6.0 ADMINISTRATIVE CONTROLS

8801140029 880106
PDR ADOCK 05000395
PDR

FIGURE 6 2-1
SOUTH CAROLINA ELECTRIC & GAS COMPANY
VIRGIL C. SUMMER NUCLEAR STATION
FUNCTIONAL ORGANIZATION

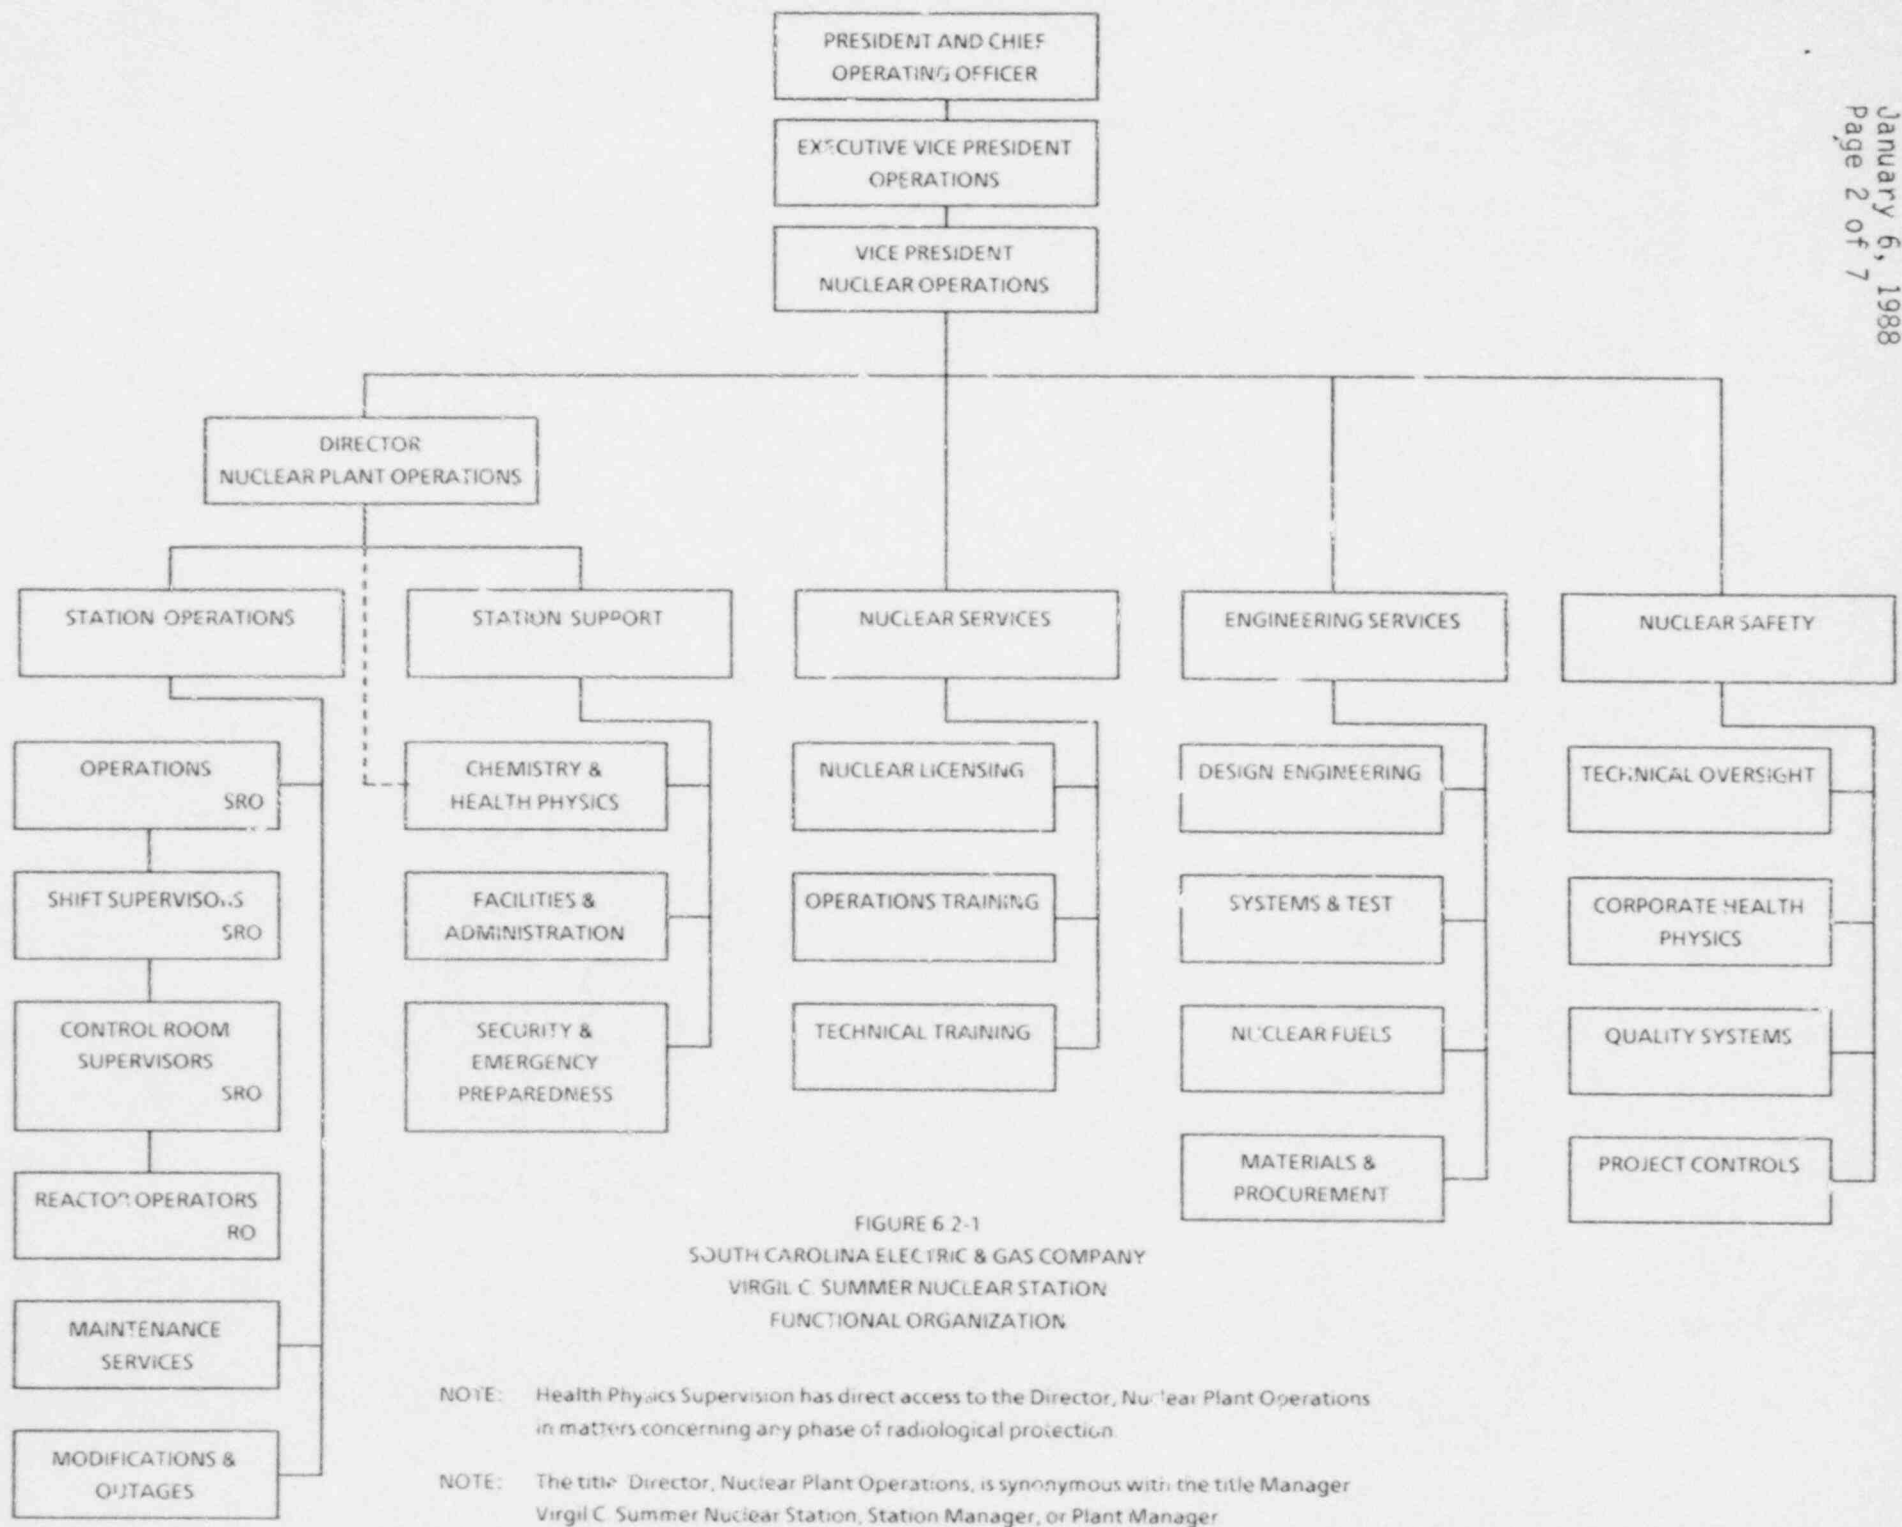
~~OFFSITE~~

6.2.1 The ^{functional}~~offsite~~ organization for unit management and technical support shall be as shown on Figure 6.2-1 and:

FIGURE 6 2-2 VIRGIL C. SUMMER NUCLEAR STATION FUNCTIONAL ORGANIZATION

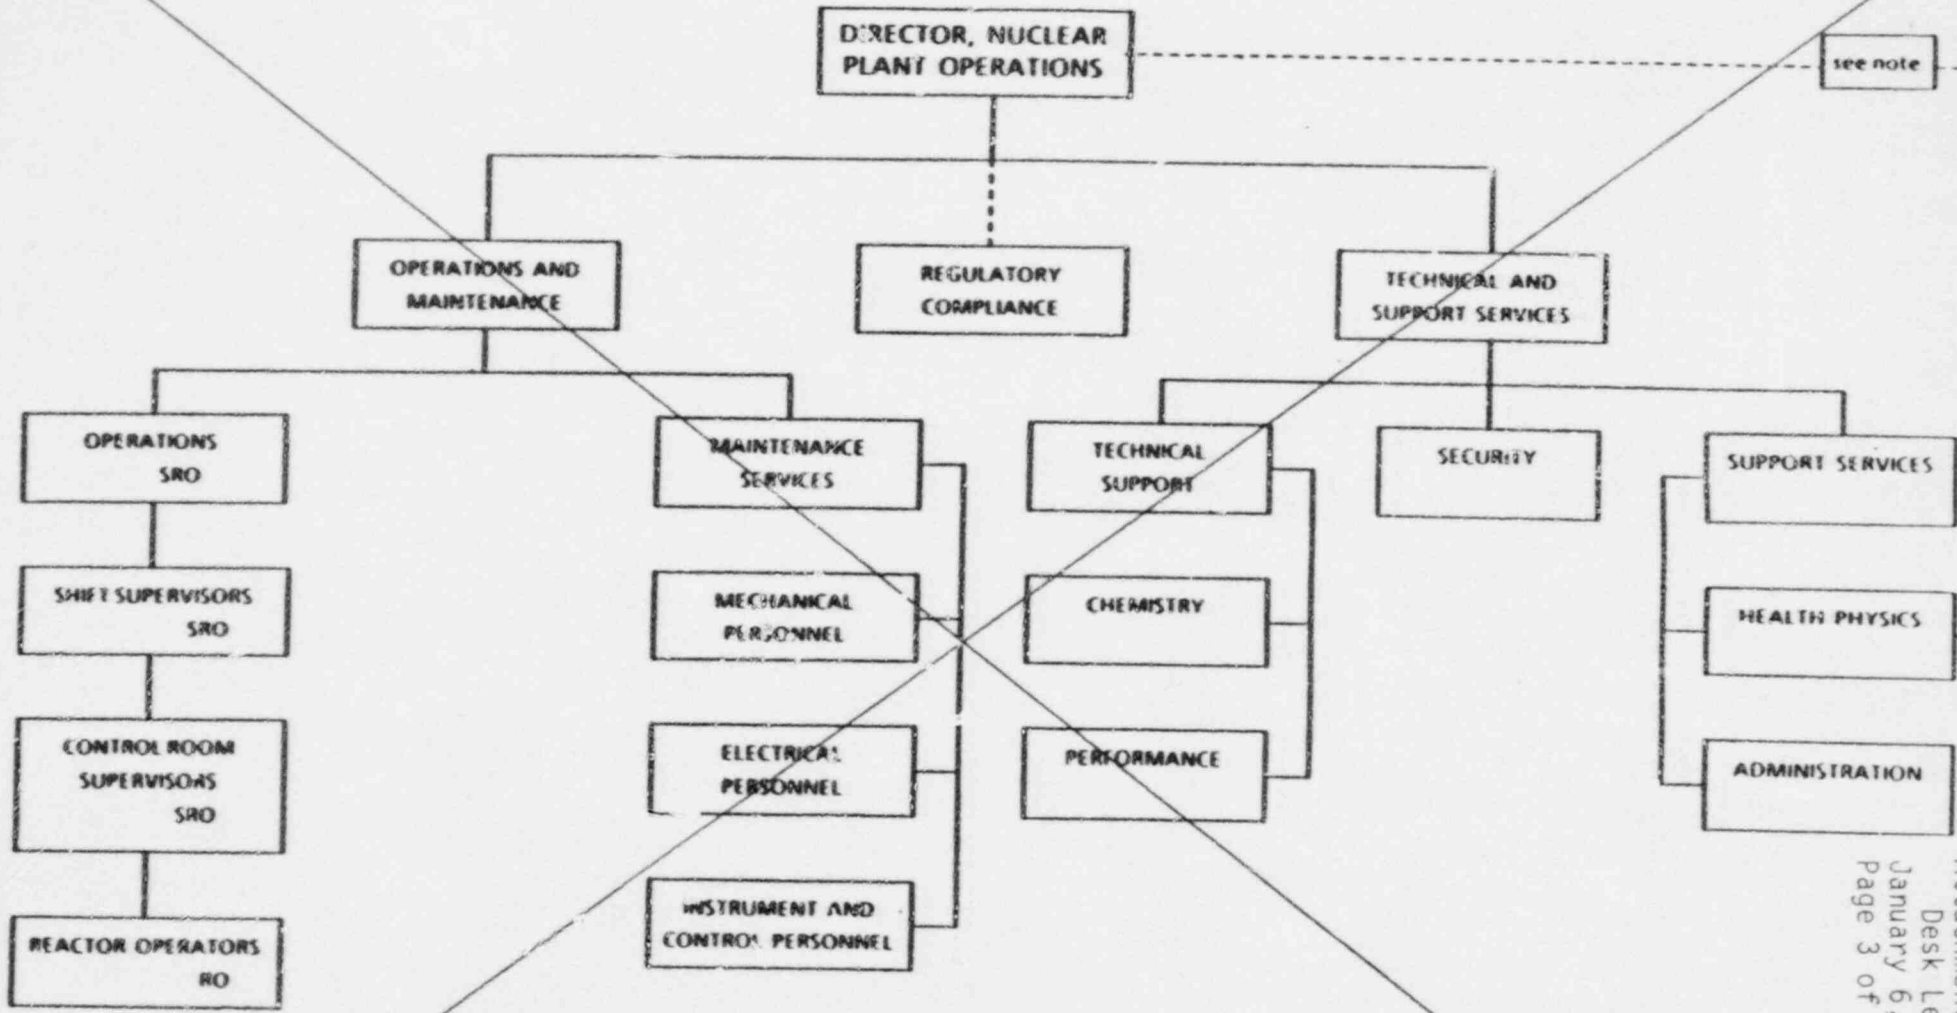
~~UNIT STAFF~~

~~6.2.2 The unit organization shall be as shown on Figure 6.2-2 and:~~

DELETE
